Modifications to Town Center and Waterfront Plan Chapters 1 through 8 of Public Review Draft (April 2014)

Exhibit A

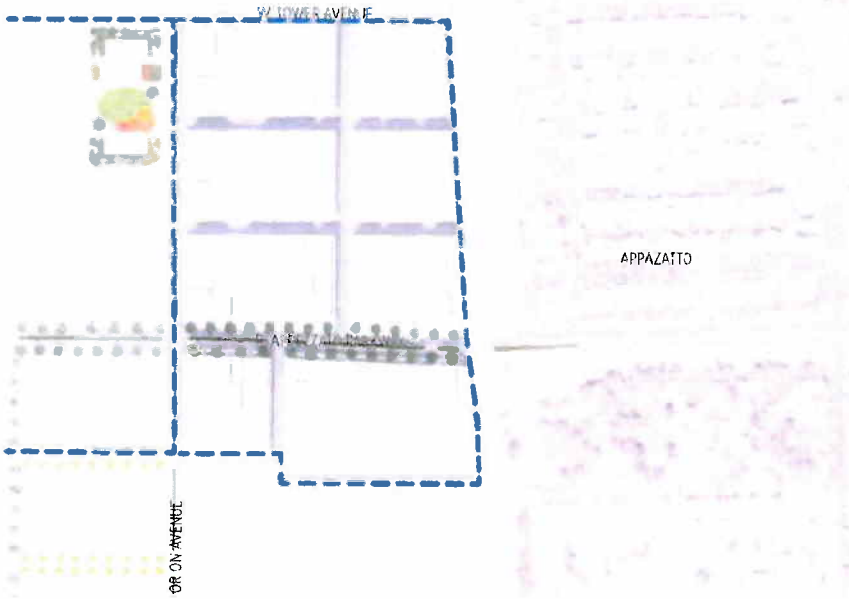
33. Page 27: Town Center Core Sub-Area graphic, add boundary lines (shown in red on Exhibit A) to graphic. Label new boundary areas as, "Seaplane Plaza" and "Seaplane Plaza Planning Area," as shown highlighted in Exhibit A (no need to highlight final version).

TOWN CENTER CORE SUB-DISTRICT

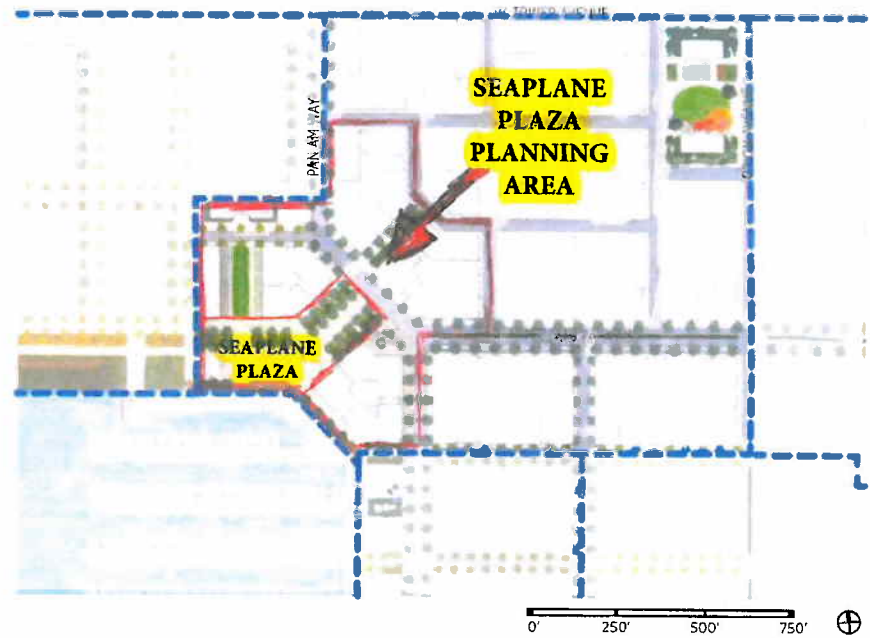
30. Page 26: Change "CONCEPTUAL PLANNING AREAS" to "PLANNING SUB AREAS" header.
31. Page 27: Add graphic from page 89, if possible.
32. Page 27: Change name of "Town Center Core Sub-District" graphic to "Town Center Core Sub-Area"

34. Page 27: Reverse order of first (left) and third (right) graphics and corresponding text.

36. Page 27: Under "TOWN CENTER CORE" delete text all the way through, "...Districts to the South," and capitalize "the" to begin the sentence.
37. Page 27: Third column, delete text, "intended as" in the first sentence.

38. Page 27: Third Column, last sentence that transitions to the fourth column should read, "The Seaplane Plaza area within the Town Center Core is comprised of vertical mixed-use development, with multi-family residential above retail, restaurant, hotel, office and other commercial amenities, concentrated around the intersection of R. Appezato, Ferry Point Road, and Pan Am Way."

39. Page 27: Fourth column, second sentence, should read, "The Seaplane Plaza, a civic waterfront plaza fronted by restaurants, museums, cafes and shops, enclosed by high quality new buildings, provides a distinct sense of arrival at the heart of the Town Center Core."
